ORIGINATION FORM

Proposed Revisions to a Standard Plans Index

Index Number: 521-650

Index Title: Light Pole Pedestal - Wall Coping

TABLE 1 DESIGN LIMITATION FOR ANCHOR BOLTS (1" Dia.)

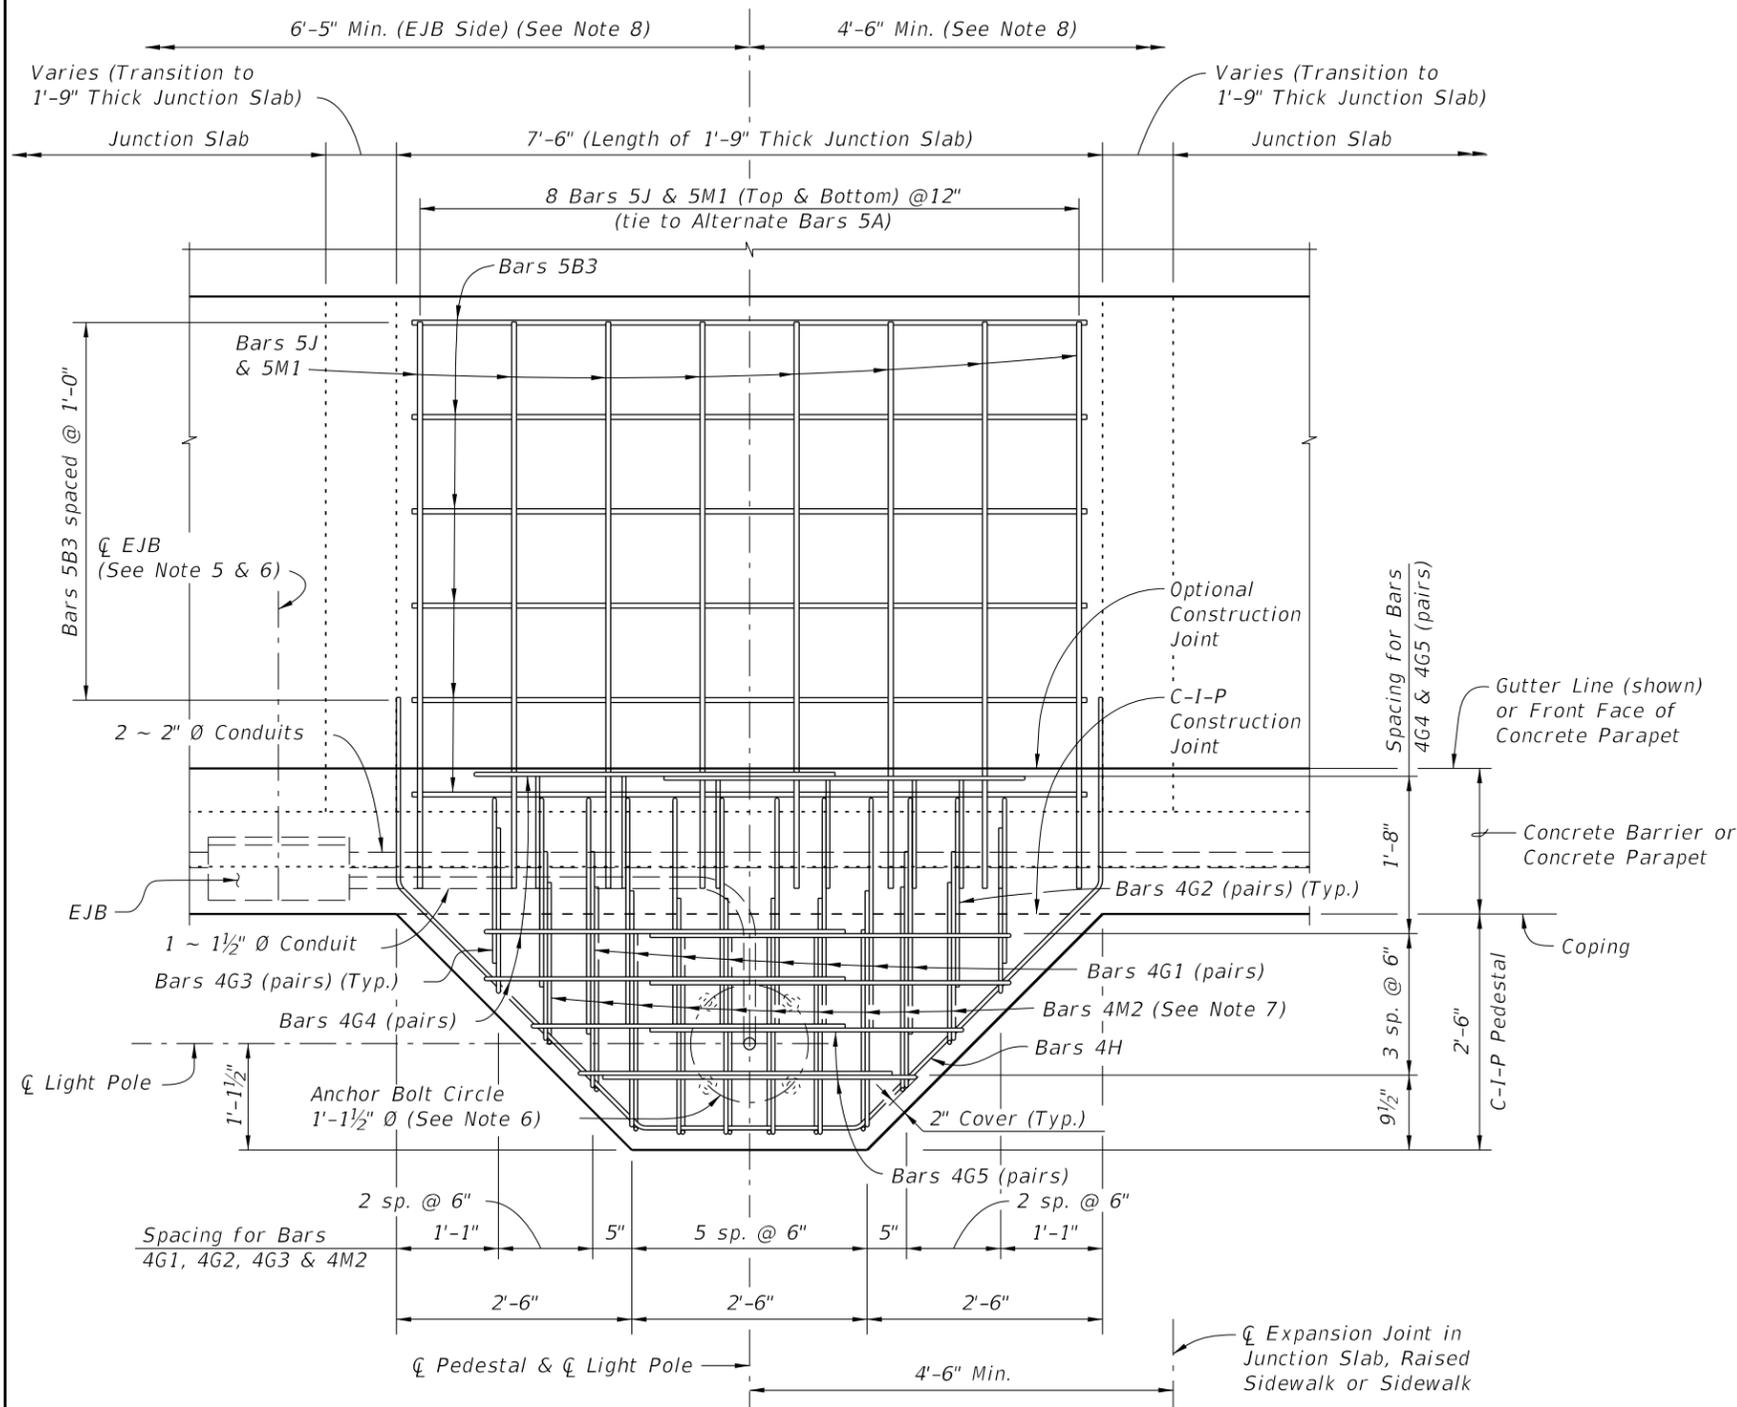
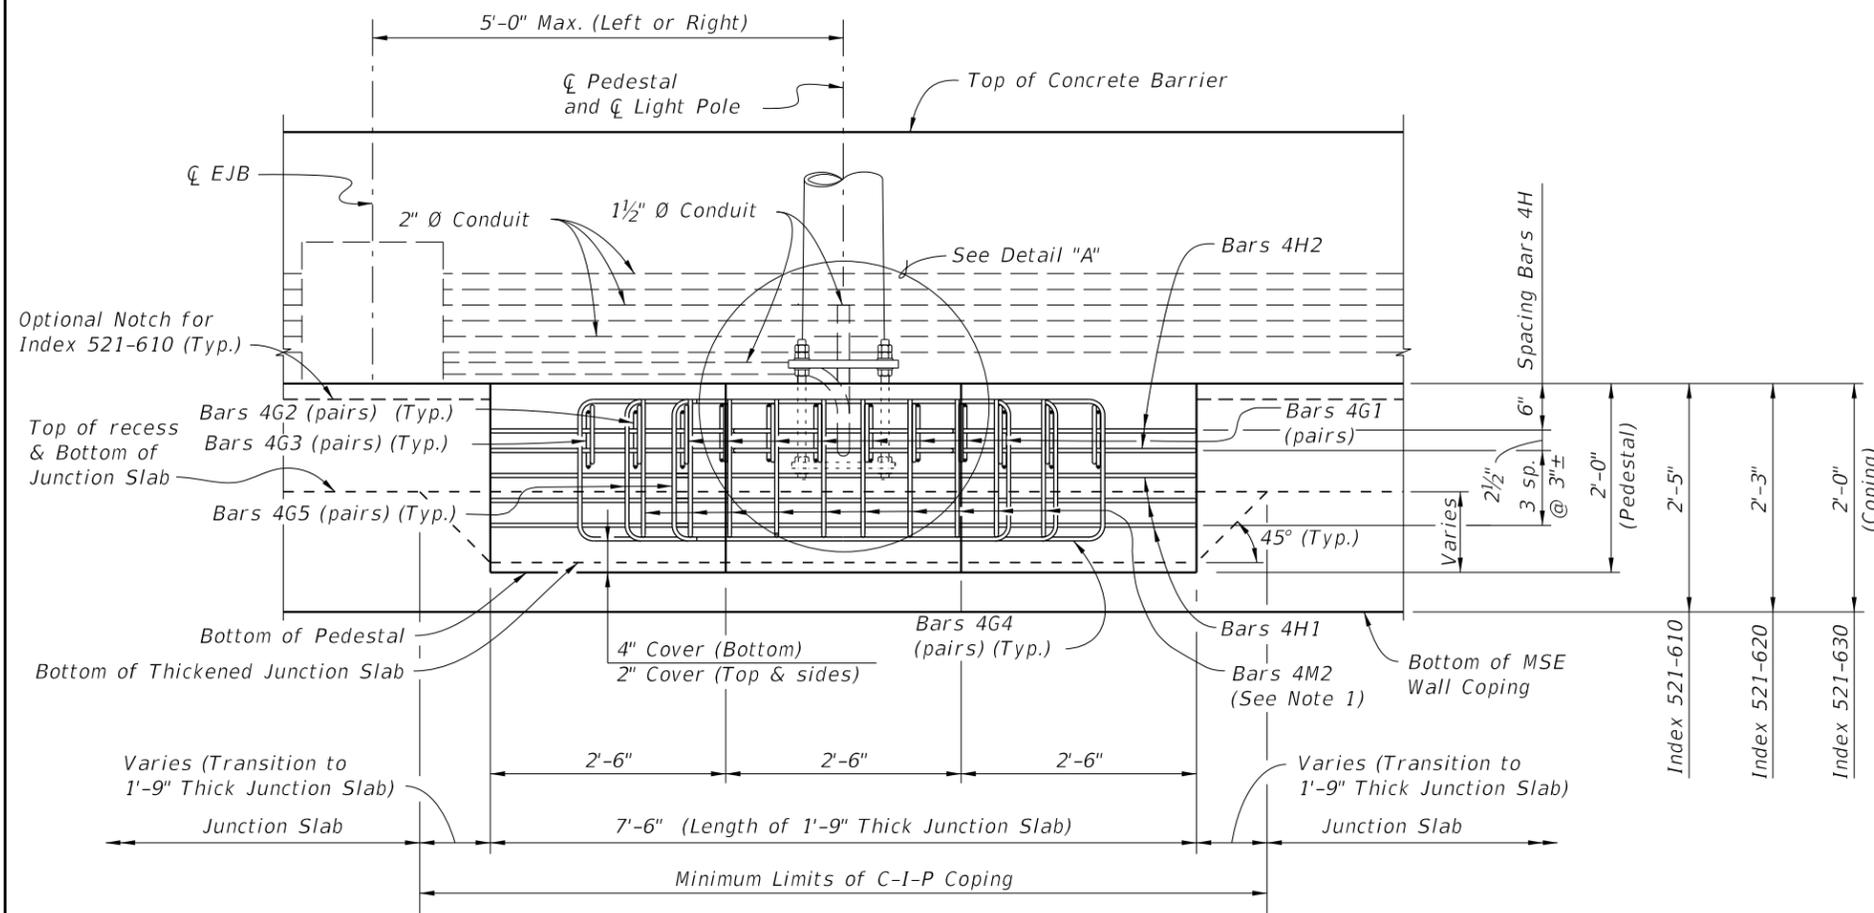
Sheet 1: Table 1 - Changed the column headings to "Top of Pedestal Height (Ft.)" and "Luminaire Mounting Height";
Note 10 - Added Index 521-611 reference

Sheet 1: The Table 1 column headings were revised to better define the height restrictions shown

Top of Pedestal Height (Ft.)*
 Luminaire Mounting Height

DETAIL "A"

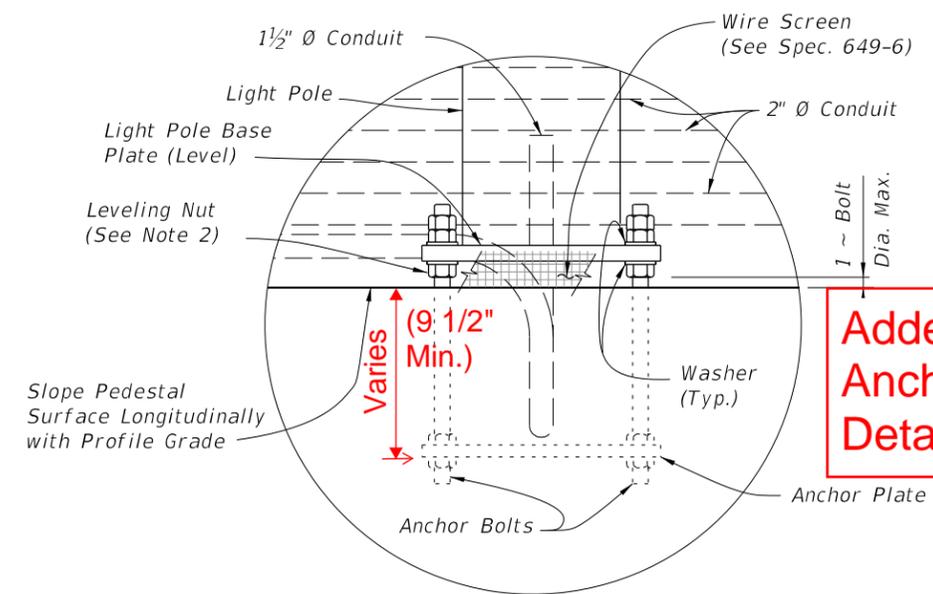
Sheet 3: Detail "A" - Added minimum depth for base plate; Added new Anchor Plate Detail

Sheet 3: More information was provided to clarify the anchor plate design and placement. The new anchor plate detail is based on Index 521-660, Sheet 4.

Added new Anchor Plate Detail

Moved Here
